# Borough of Wilkinsburg

### **Bid Specs Addendum**

This is an addendum to the request for proposals for the 605 Ross Avenue exterior masonry repair project that was advertised on June 29, 2023. This addendum is a result of the pre-bid meeting held at 605 Ross avenue at 10:00 a.m., July 10, 2023.

Image 1

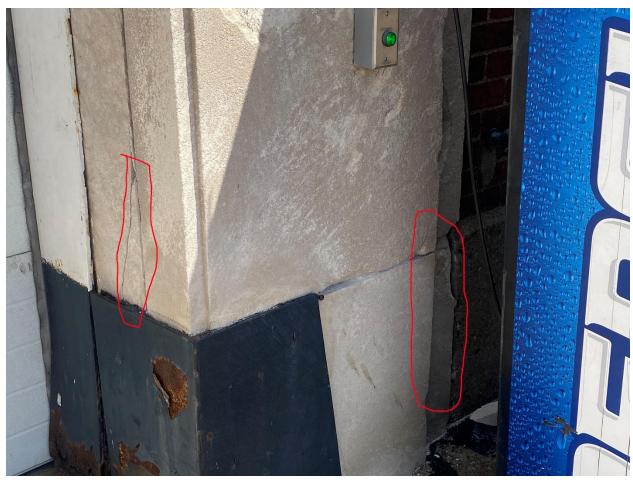
- 10) Limestone replacement and repair
  - a. Replace two lower panels on left and right of front door
  - b. Upper right section above fire department garage door: Remove panels indicated in *Image 1*. Treat underlying steel, install flashing, install new concrete panels.
